SITE AUDIT REPORT AND SITE AUDIT STATEMENTS

Caddens Release Area, Kingswood, NSW, 2747

Report Number: 097623019 007 R Rev0

Figure 12 Groundwater Flow

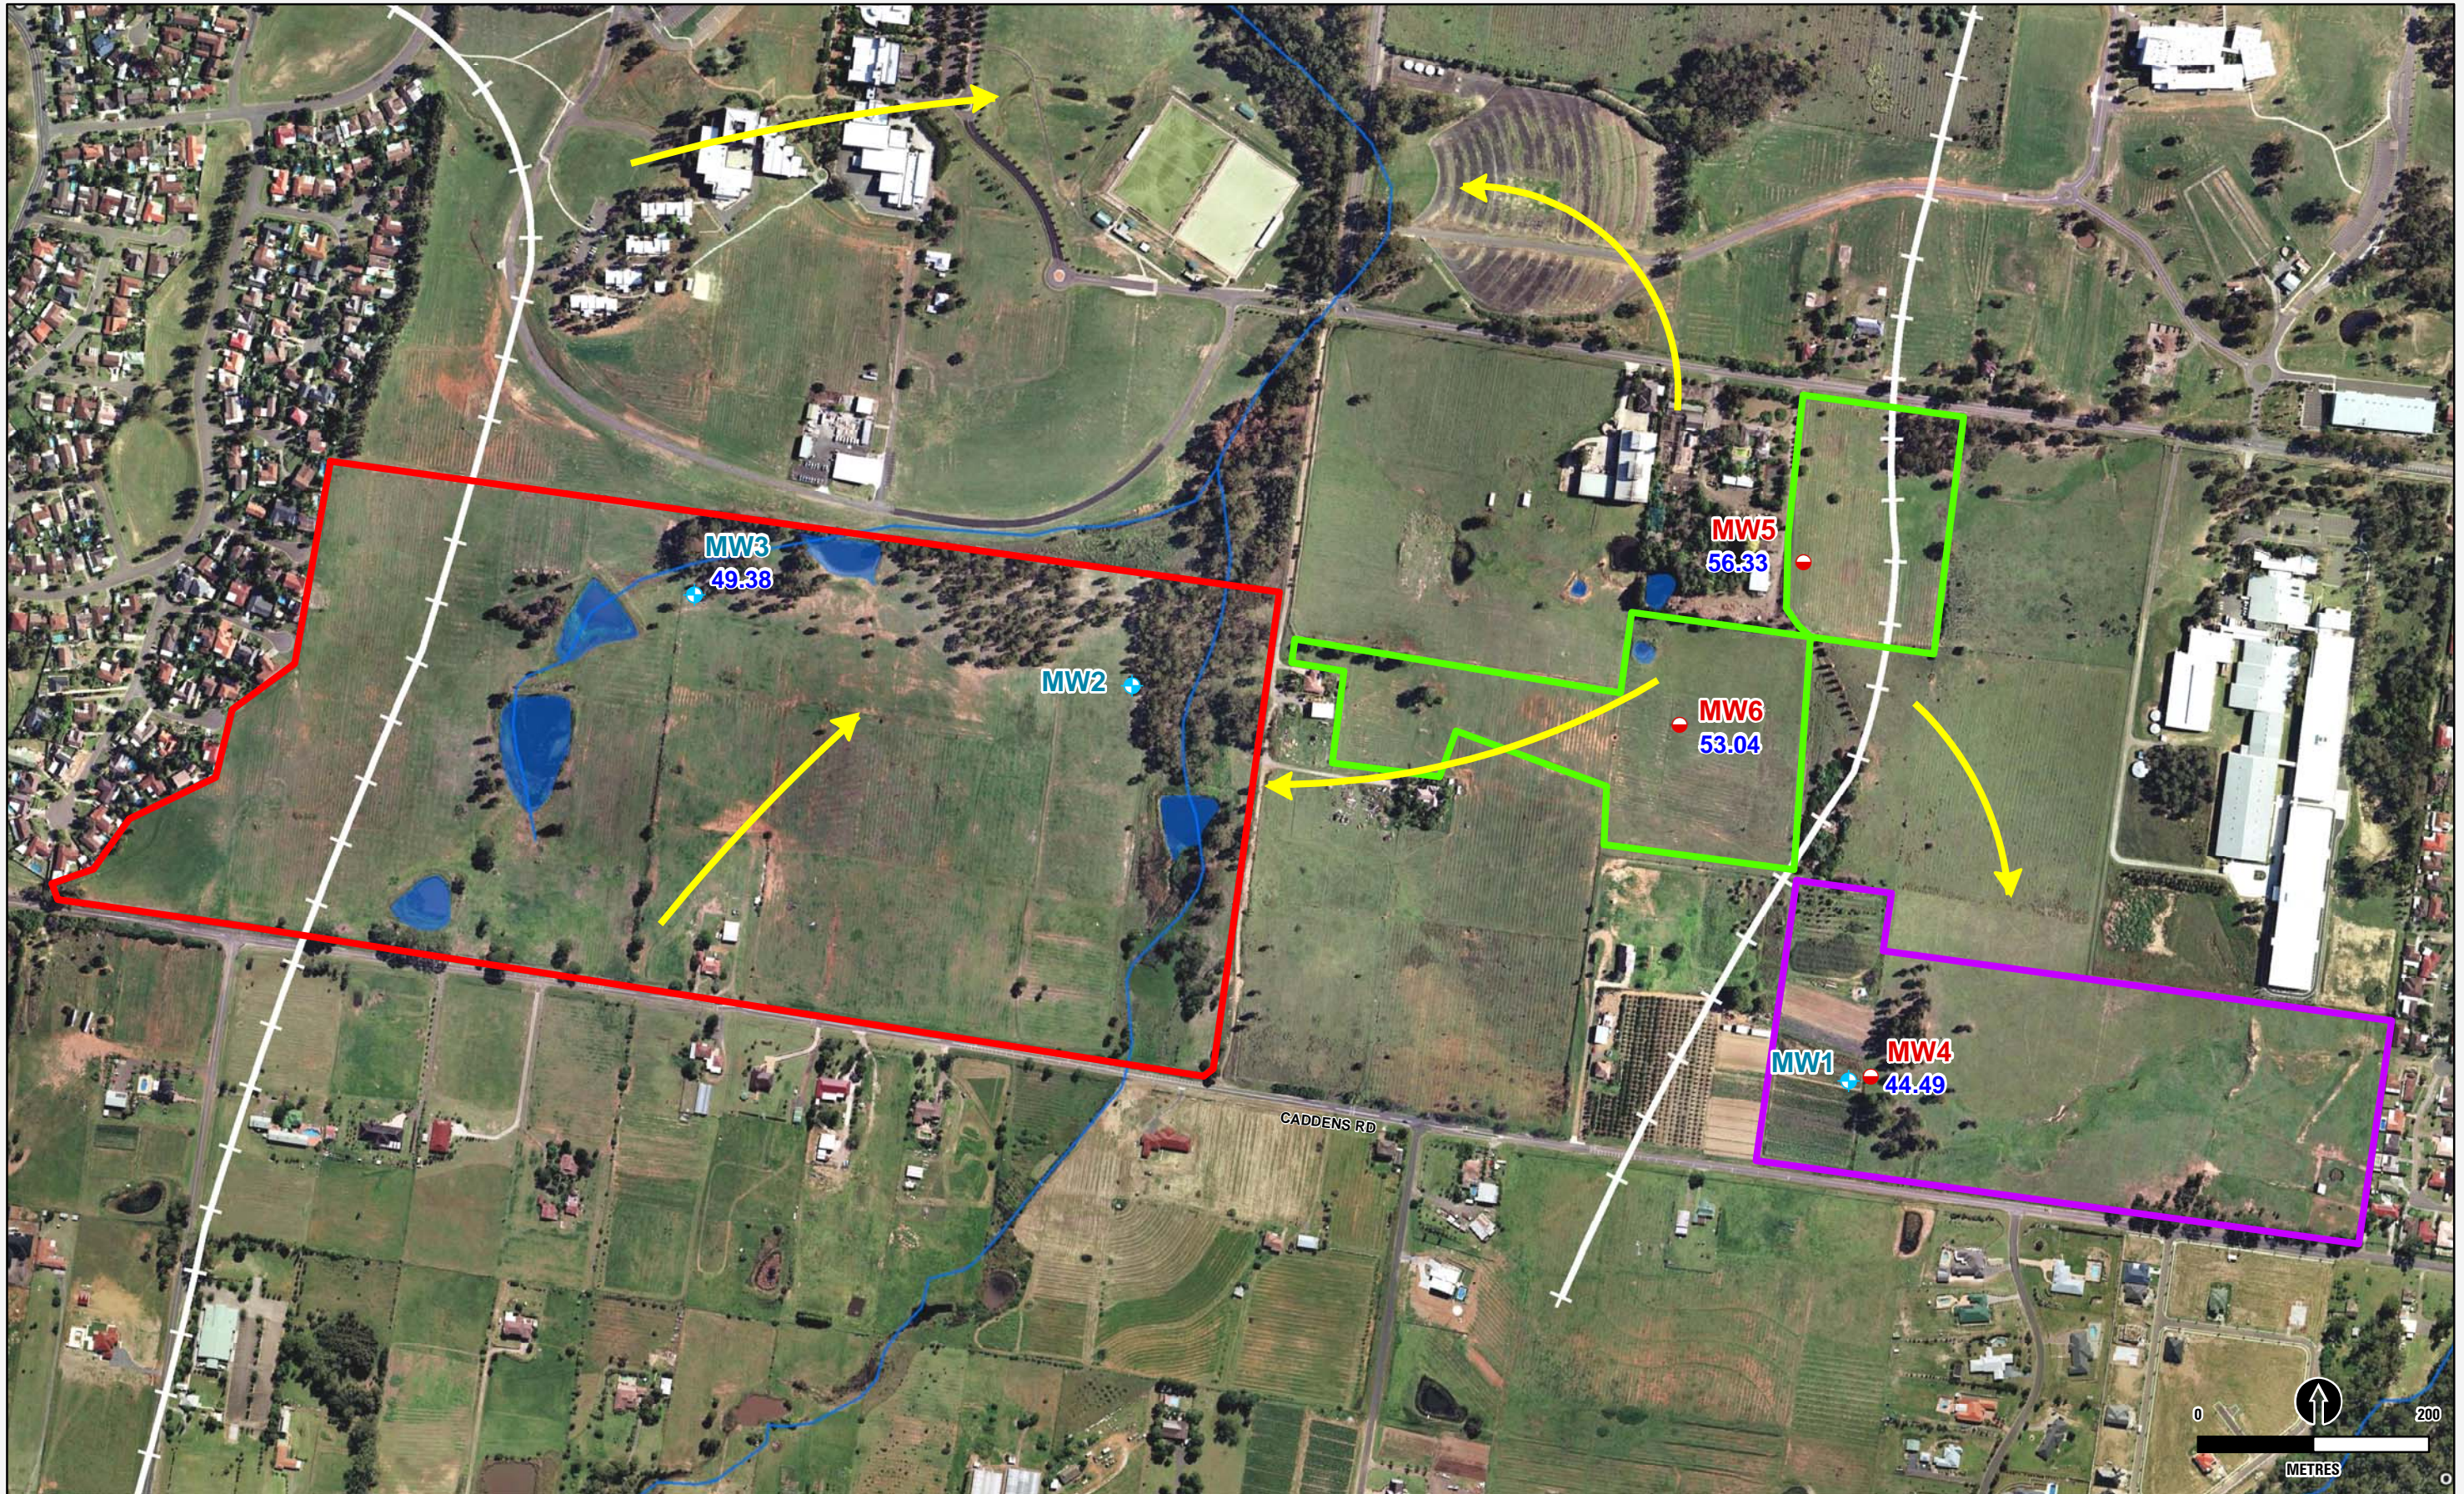
Table 8-4 references Figure 12 which presents interpreted groundwater contours which are plotted to flow in a southerly direction radiating from well MW5. This interpretation contradicts the direction of flow inferred from published information (Section 3.4), and the direction of flow of the creek that bisects the Site.”

The Site is bisected by Werrington Creek that flows to the north. Monitoring wells MW4-MW6 and MW3 are located on the western side eastern side of the creek respectively. The interpretation of groundwater flow on Figure 12 (PB, 2009b) was undertaken incorrectly by contouring the elevation of the watertable and ignoring the influence of the drainage lines. It is assessed there is insufficient data to contour the groundwater elevation to produce a potentiometric head contour map.

Reference to the topographic map indicates the Site is intersected by catchment boundaries to the east and west as shown on Figure 12. The watertable elevation in an unconfined aquifer is typically a subdued reflection of the topographic surface. Groundwater flow is inferred to be perpendicular to the catchment boundary and towards the creek systems. Thus groundwater flow at the eastern part of the Site is radial from MW5 (centred on a local topographic high) and elsewhere generally northward flowing in the direction of Werrington Creek. Analysis of groundwater levels from monitoring wells MW4, MW5 and MW6 confirm local groundwater flow (in the south eastern part of the Site) is in a south-westerly direction towards Werrington Creek.
